## LEGAL NOTICE EXETER PLANNING BOARD AGENDA

**Date:** August 8, 2022  
**To:** Planning Board  
**From:** Dave Sharples, Town Planner  
**Re:** Willey Creek Company PB Case #22-3

**Date:** August 11, 2022  
**To:** Planning Board  
**From:** Dave Sharples, Town Planner  
**Re:** Glerups, Inc. PB Case #22-9

**PLUNGE POOL NOT TO SCALE**

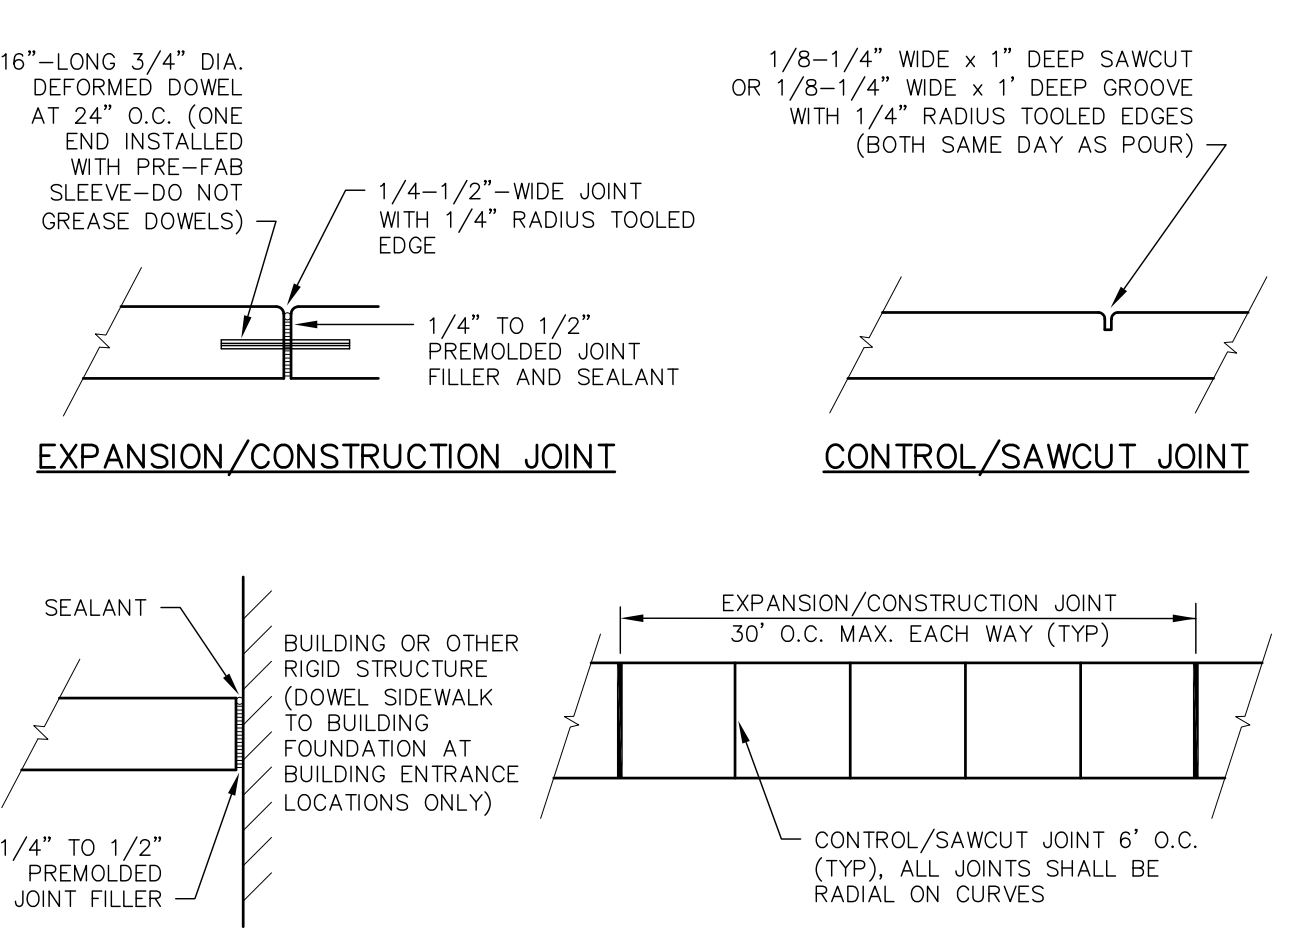
4. The plunge pool detail on sheet C-10 refers to lengths and widths as shown on plan. Dimensions should be added to the plan at each plunge pool, or a table of dimensions. Please confirm plunge pools currently shown at the property lines will not cross property lines.

3. The 12” pipe discharging from CB#1 has been changed to RCP and the rim raised to increase cover.
4. The plunge pools shown on Sheet C-3 are now referred to with individual dimensions and the corresponding detail on Sheet C-10 updated as appropriate.
